**McLoughlin Amenity Funds:
Waterfront Parks – Public
Engagement Results**

Esquimalt Gorge Park and Saxe Point
Park

October 16, 2019

Stantec Consulting Ltd.

Building concept 1 would provide the following:

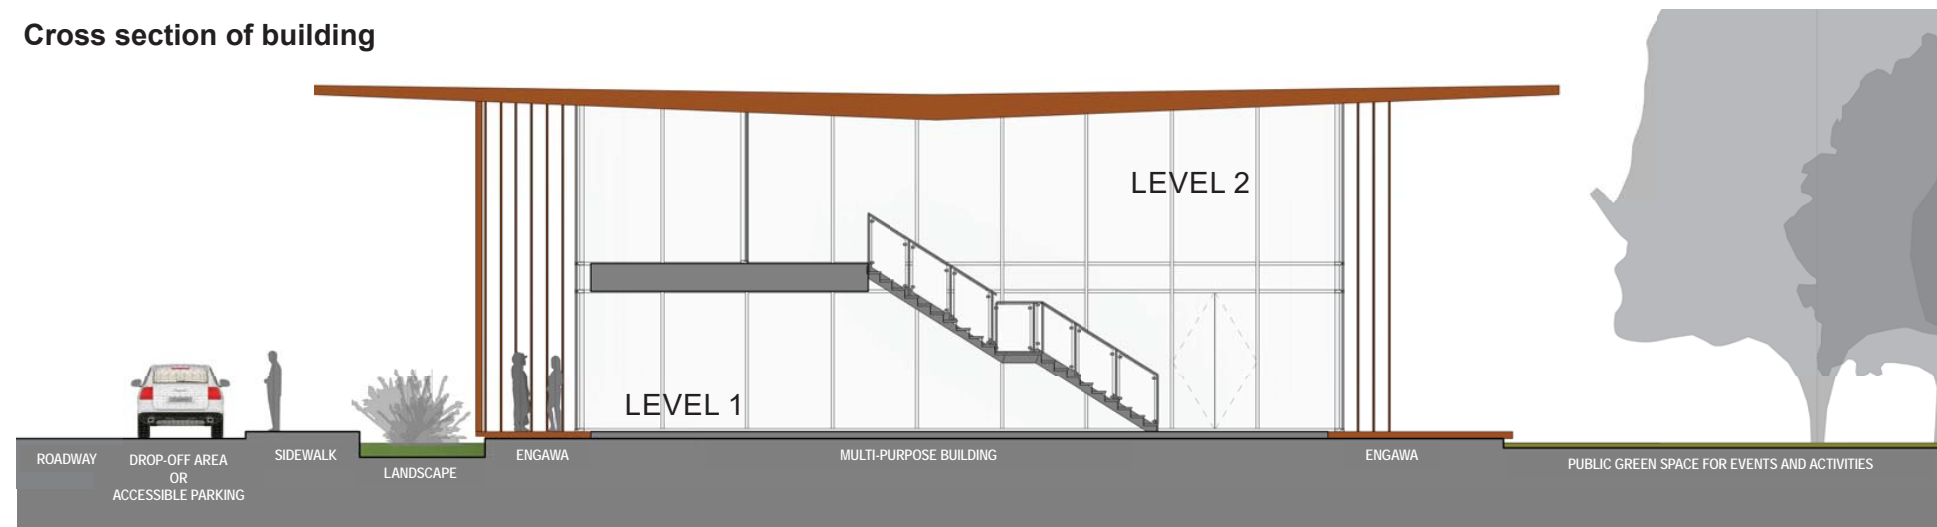
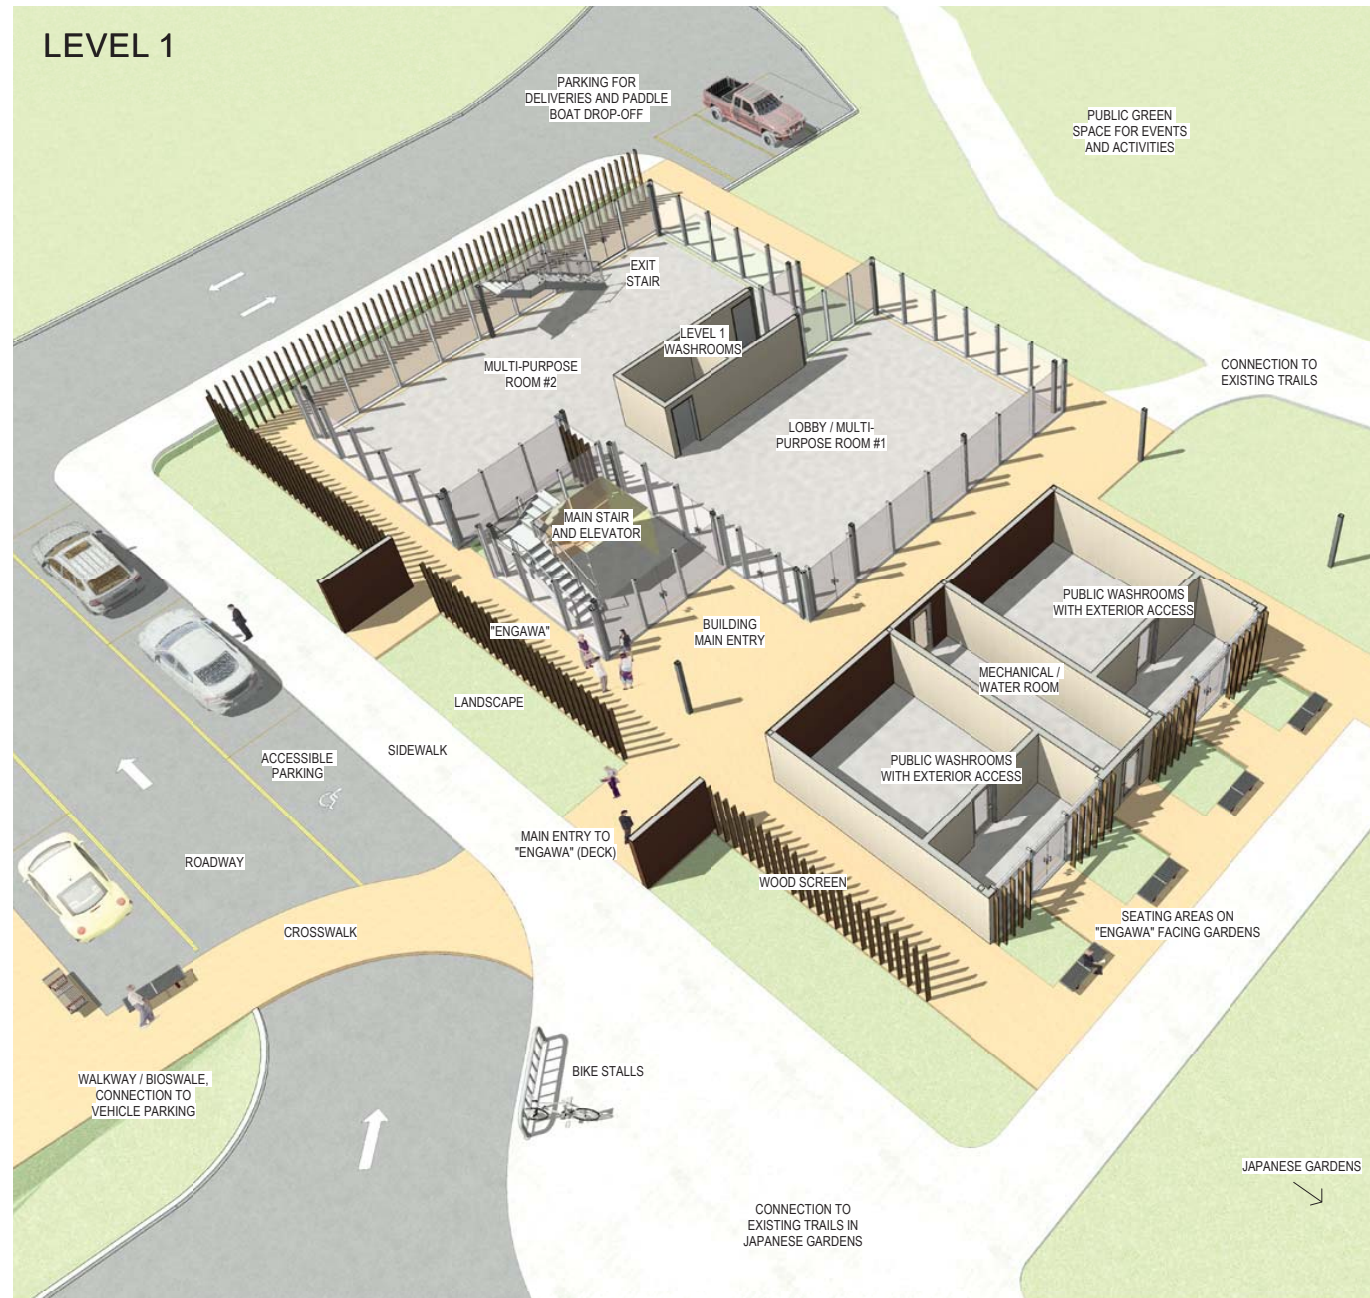
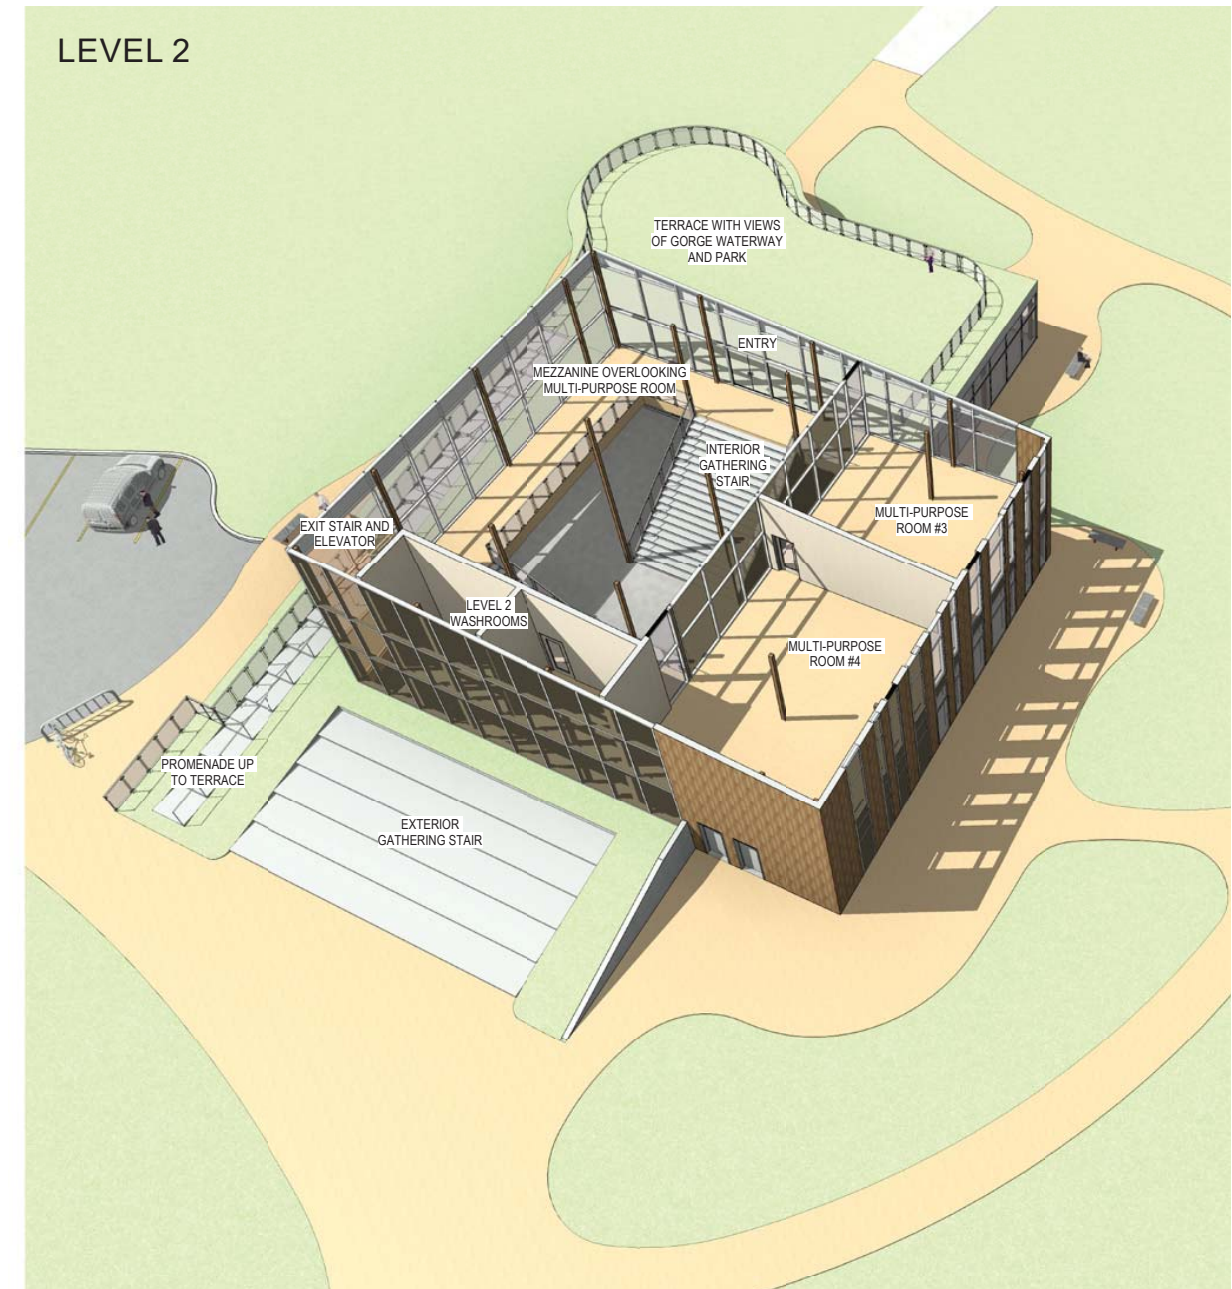
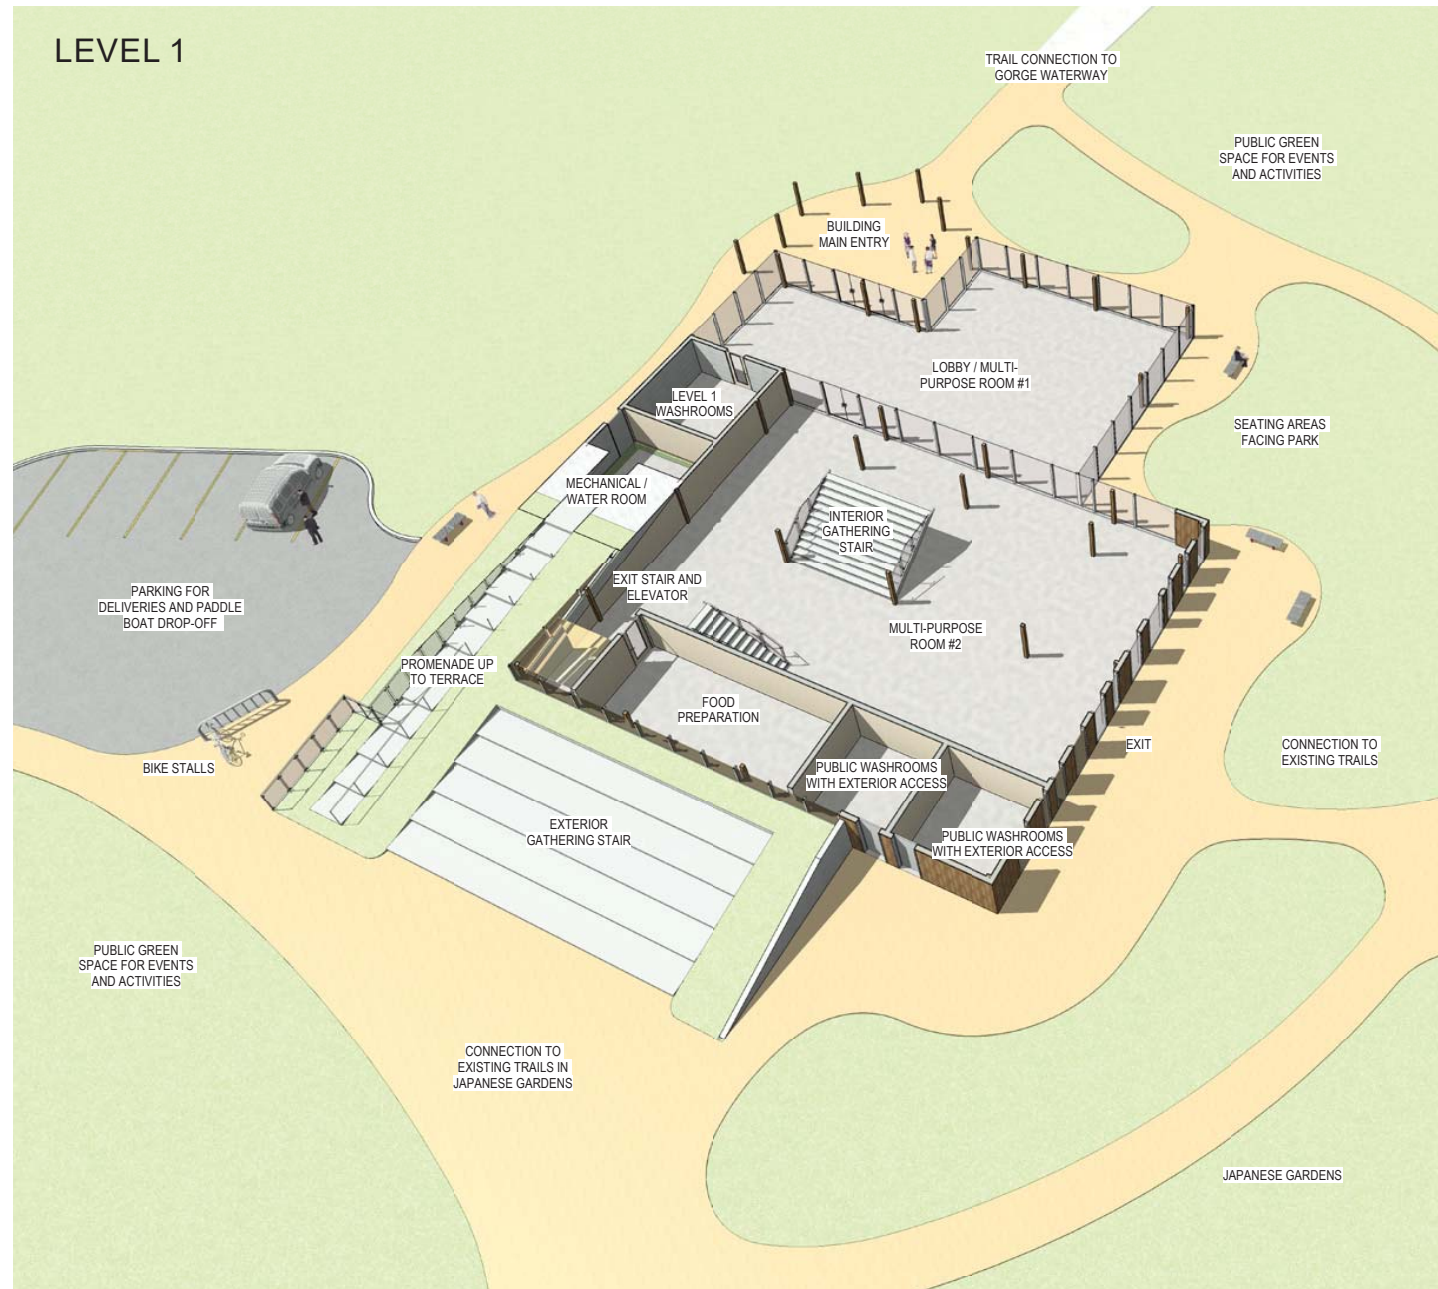
Participants expressed concern about maintaining green space and inquired if the building or the parking area could be smaller. There were also requests to maintain the park as it is and to not build a building.

Participants commented that the building did not meet their vision of a Japanese Tea House and asked for a smaller scale building (both in footprint and single story) with commercial food and beverage space and washrooms. There was a positive response to the Engawa but requests for more Japanese design elements and a more traditional appearance to the building.

- The amount of exposed glass in Concept 2 may cause fatalities for birds striking glass, particularly with the location of the building between the waterway and the gardens
